DANE COUNTY DEPARTMENT of PUBLIC WORKS, HIGHWAY and TRANSPORTATION

RFB NO. 309025 - ADDENDUM NO. 2

GAS COMPRESSOR BUILDING

Enclosures: Drawing 6 – Gas Compression Equipment & Pipe Locations

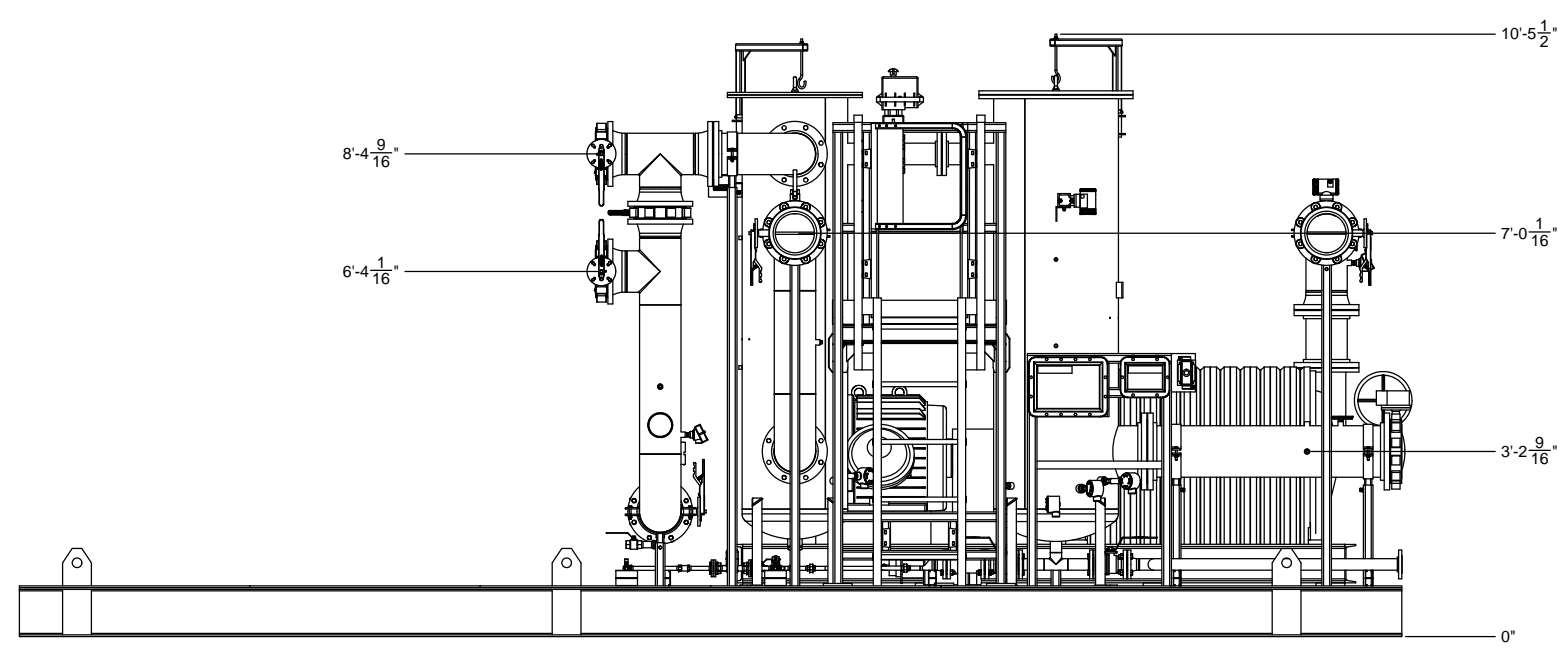
Equipment piping will be in place before this Work, as shown on the attached Drawing. Pipes 1, 2, 3, and 4 will extend beyond the outer walls of the new building.

Contractor must coordinate Work around piping and equipment. As described in Specification Section 13121 – Paragraph 1.3.B, coordinate bay spacing and supports with locations of piping.

Addendum 1 stated that the building must be designed to support four pipes from the roof support members until the pipes are beyond the building walls. This has been changed to require support for only three pipes. As labeled on the attached Drawing, pipes 1, 3, and 4 will require support for 9' until they reach the outer walls of the building. Pipe 2 (as labeled on the attached Drawing) will not require support from the building structure.

Where pipes 1, 2, 3, and 4 will penetrate building walls, Contractor must provide explosion proof gaskets. There are no other requirements for making this building explosion proof.

Section 13121 – Paragraph 1.4.B, delete “20 PSF dead load.”. Building must be designed to withstand the dead loads of the building and pipes 1, 3, and 4, as well as all other loads (snow, wind, etc), as required by Wisconsin Building Code.
